## HILL VALLEY - PHASE 2B

CITY PROJECT NO. 15860  
CONTRACT NO. 9680

#### REVISION 1 - 04/29/26

#### REVISION 2 - 05/28/26

15860  
 MADISON, WI  
 HILL VALLEY - PHASE 2B  
 CONTRACT NO.: 9680  
 P-12

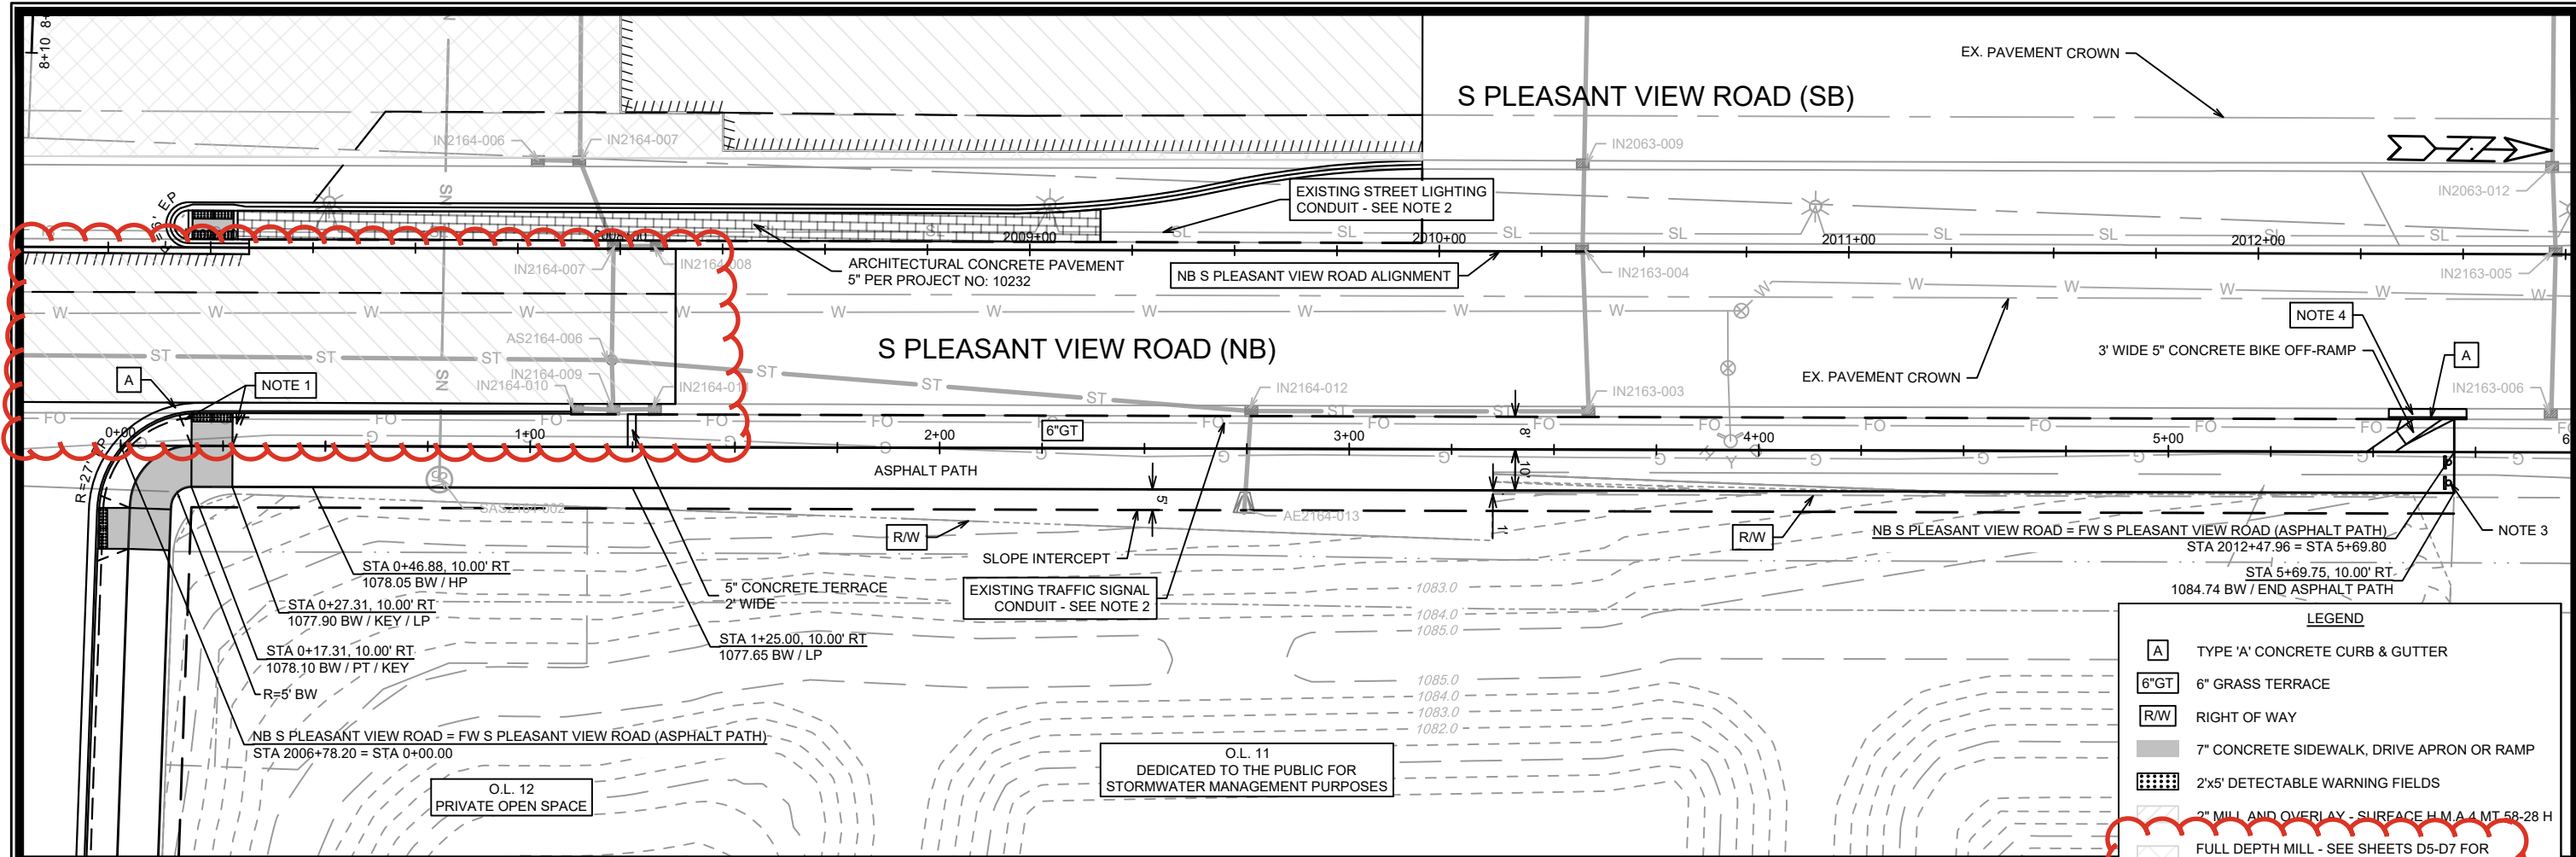
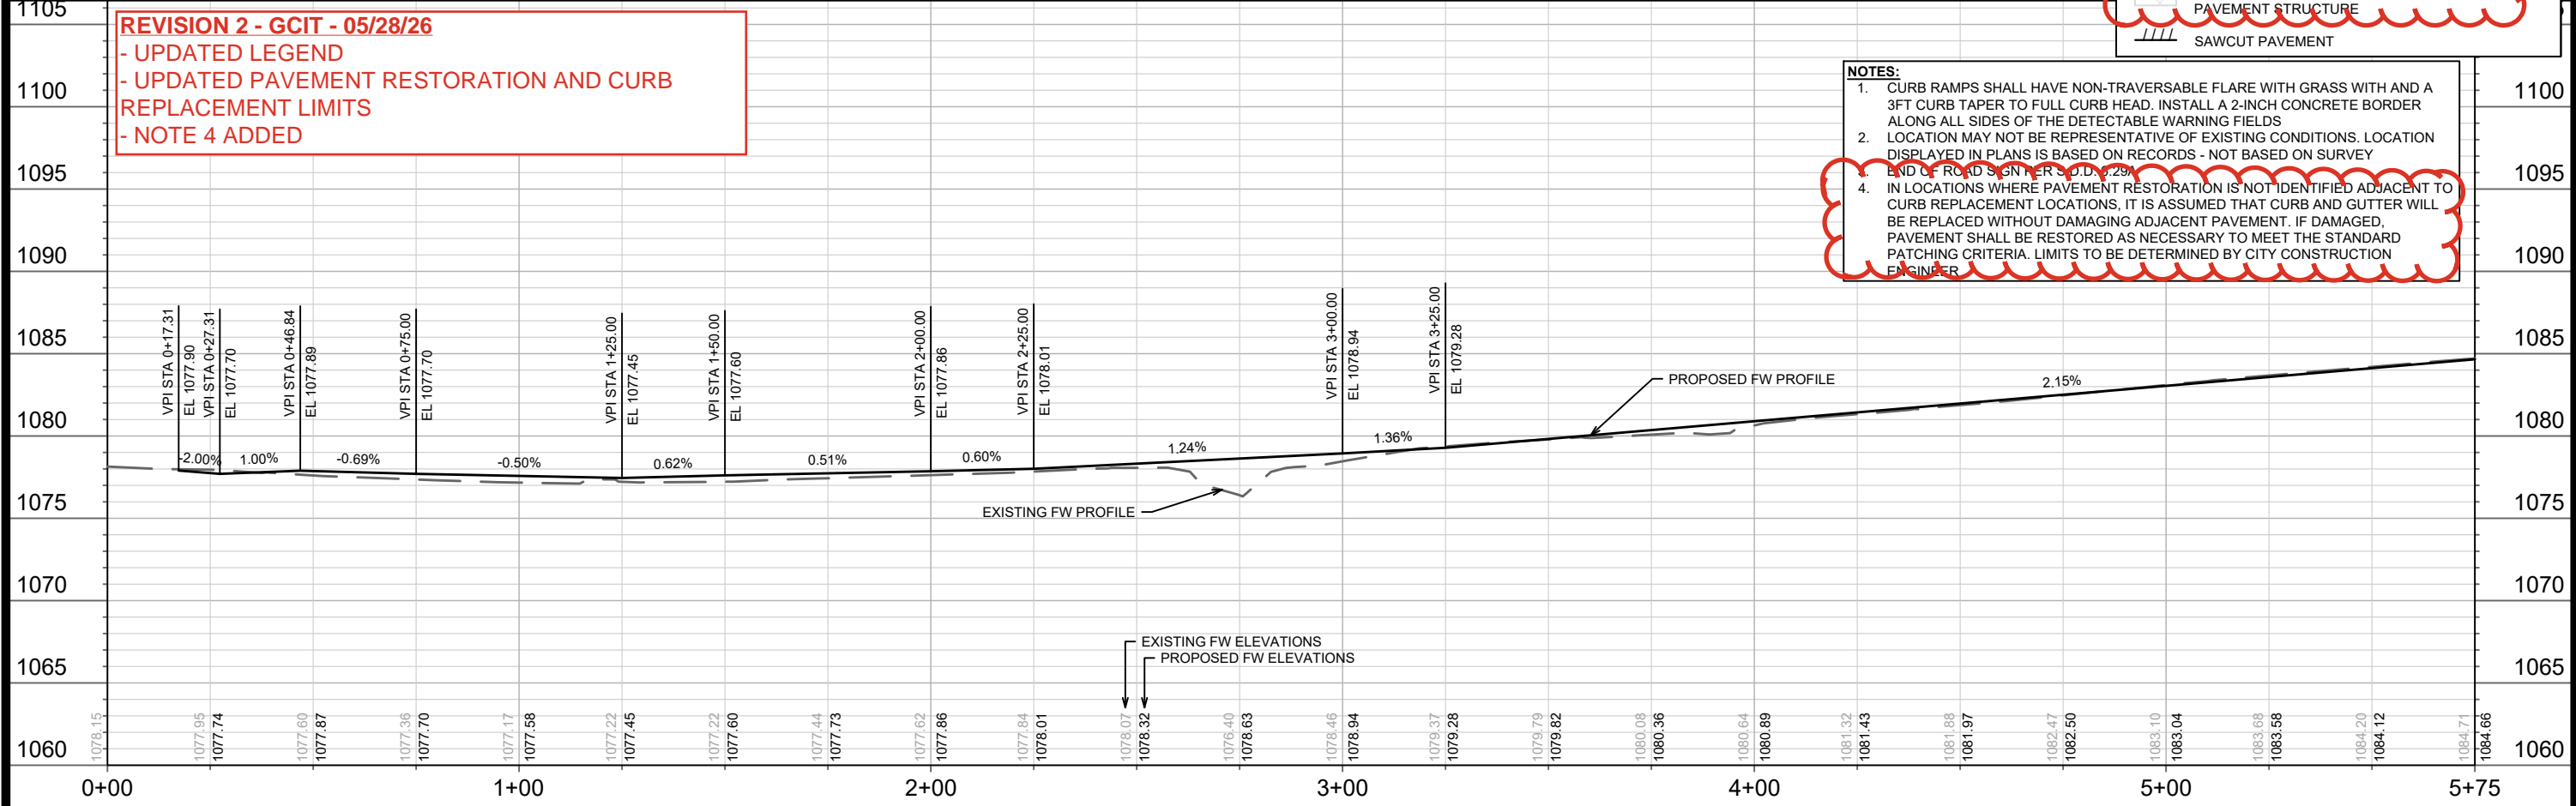
**REVISION 2 - GCIT - 05/28/26**  
 - UPDATED LEGEND  
 - UPDATED PAVEMENT RESTORATION AND CURB REPLACEMENT LIMITS  
 - NOTE 4 ADDED

PLAN & PROFILE - SEWER ACCESS ROAD  
 HILL VALLEY - PHASE 2B  
 M:\DESIGN\Projects\15860\CAD\Streets\15860EN-PnP.dwg

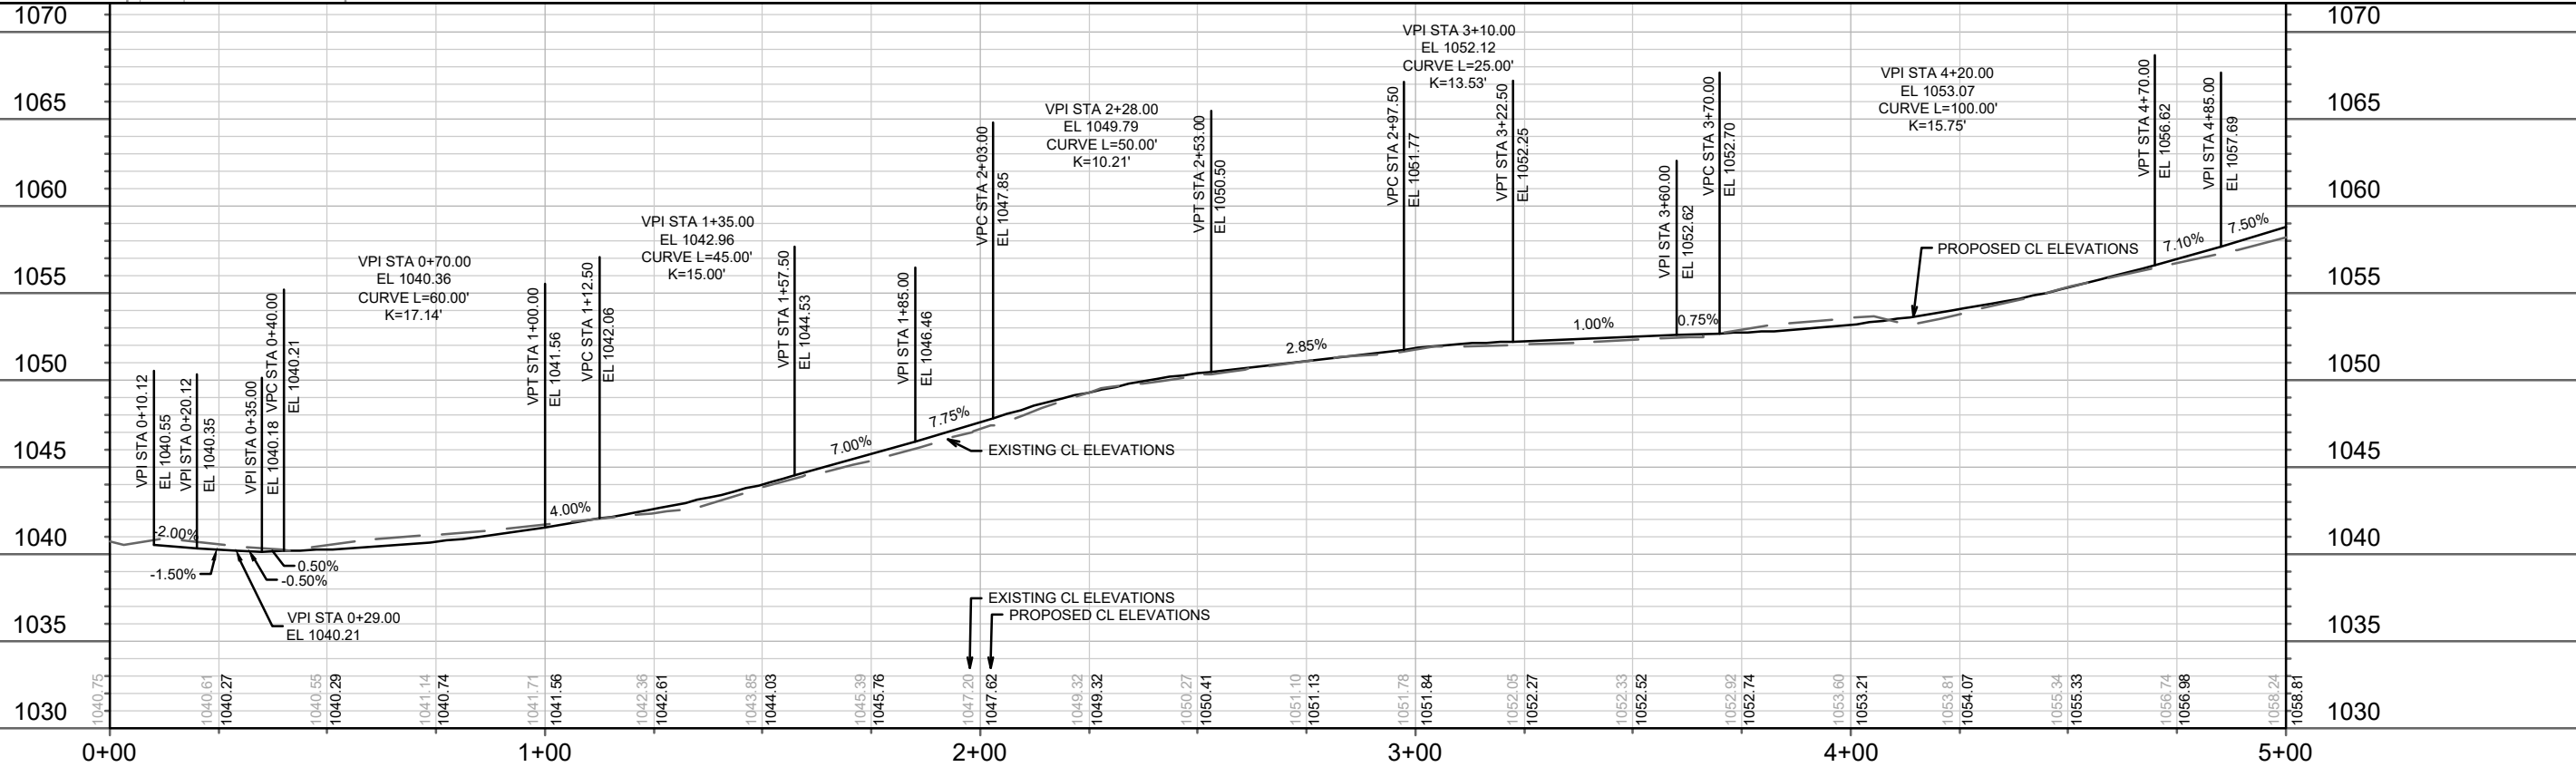
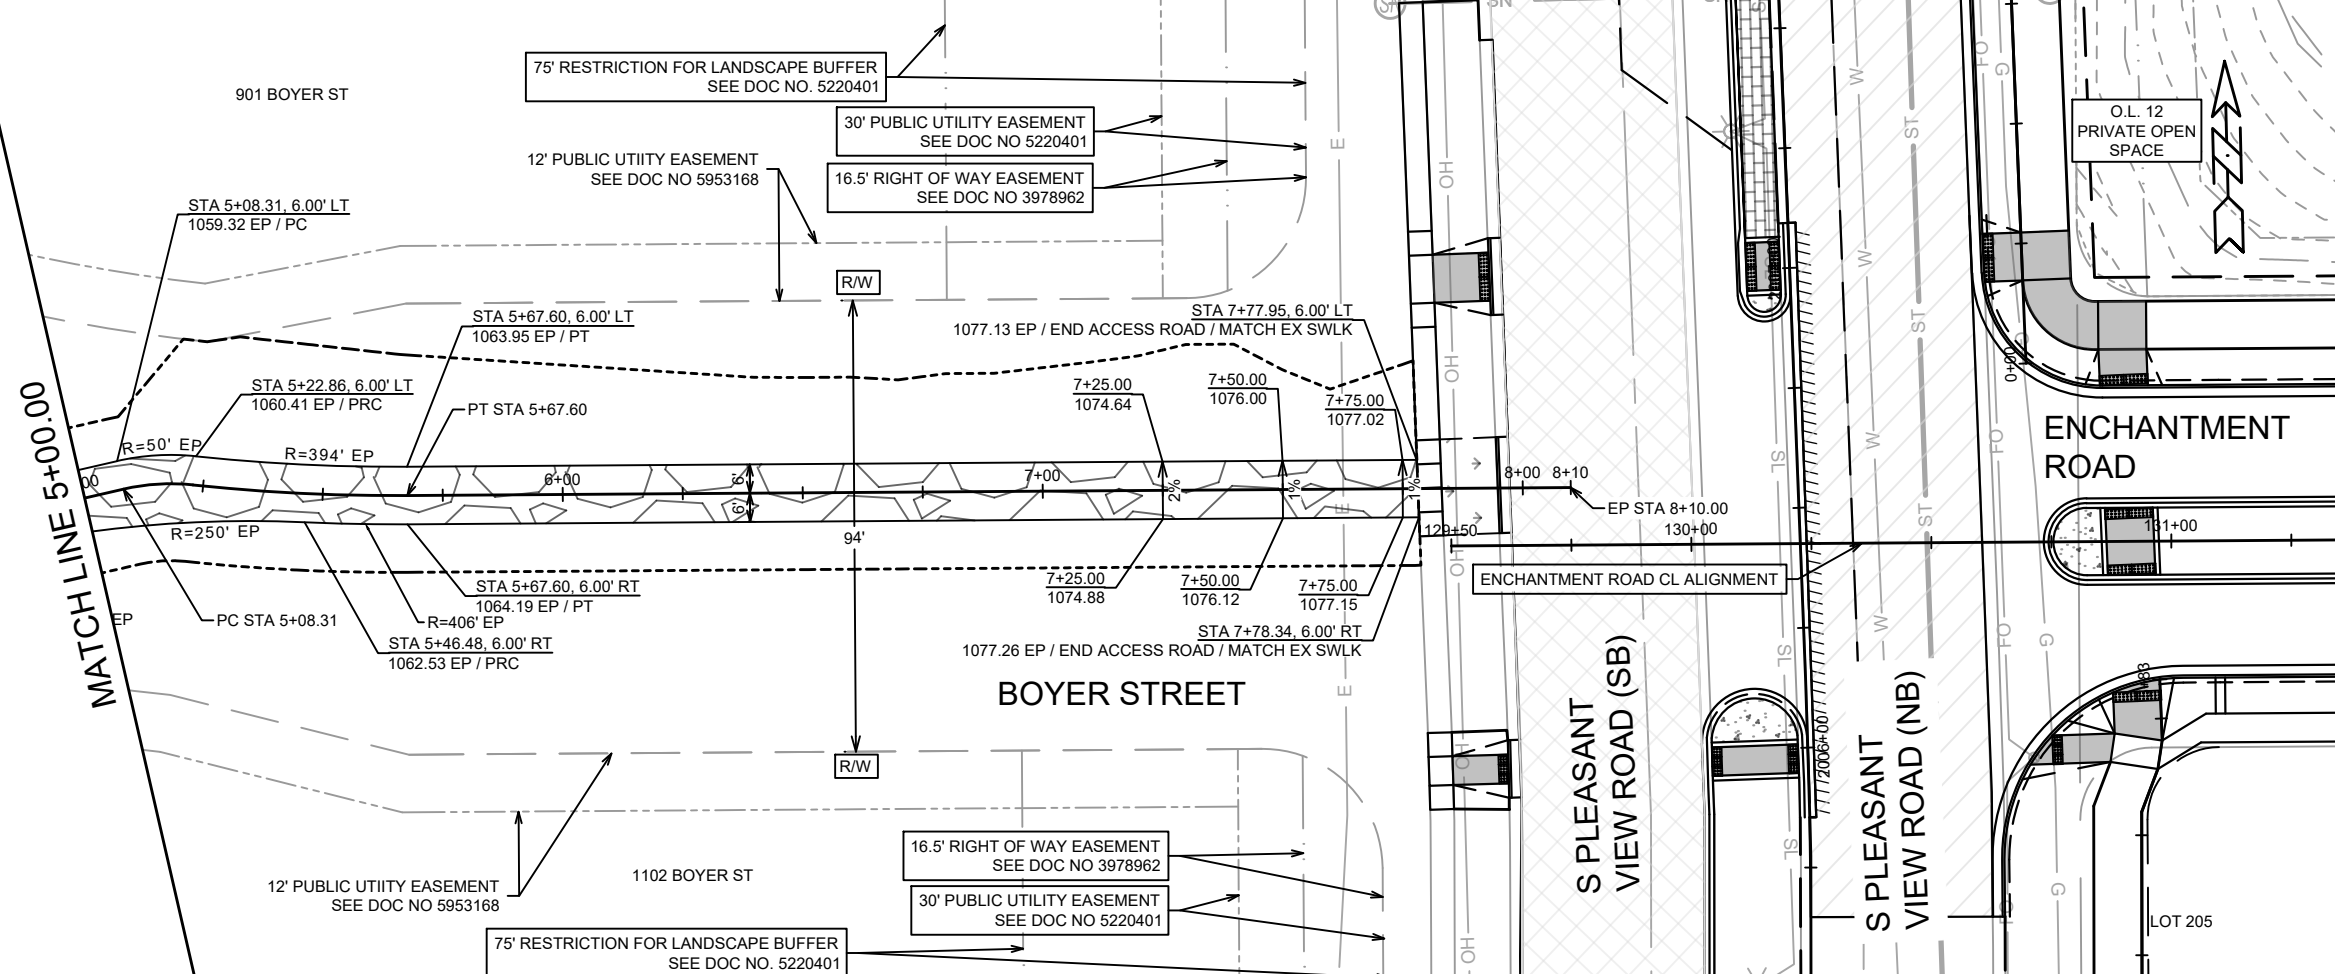
**REVISION 1 - 04/29/26 GCIT**  
**- UPDATED SEWER ACCESS ROAD S.D.D.**

UTILITIES PLAN & PROFILE - ENCHANTMENT RD  
 HILL VALLEY - PHASE 2B  
 M:\DESIGN\Projects\15860\CAD\Sewers\15860SWR-PipeNetwork.dwg

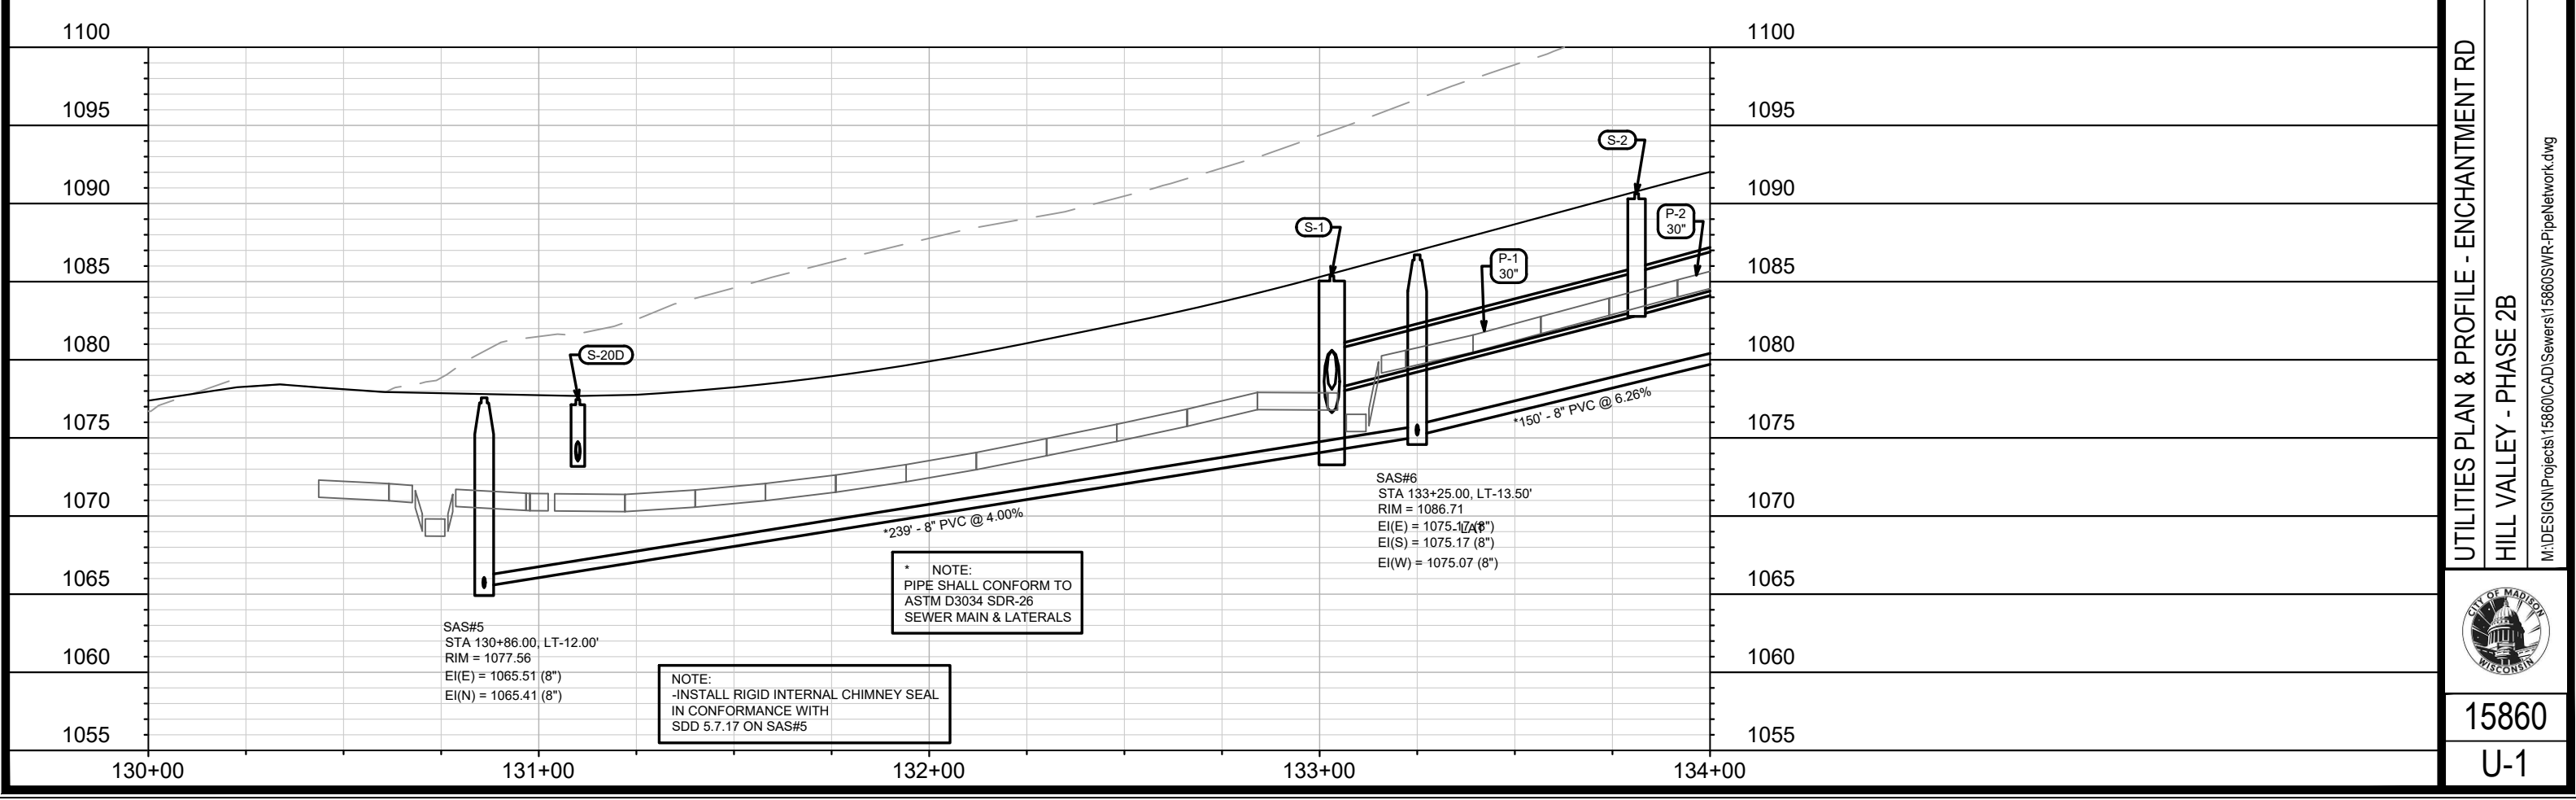
REVISED 5/28/2026 EEA  
 -Deleted structure S-20 & pipes P-20 & P-20D on Pleasant View Rd.  
 -Added pipes P-30C, P-20X, P-20Y  
 -Added structure S-20X  
 -Revised inverts on structures from S-20A to S-20D
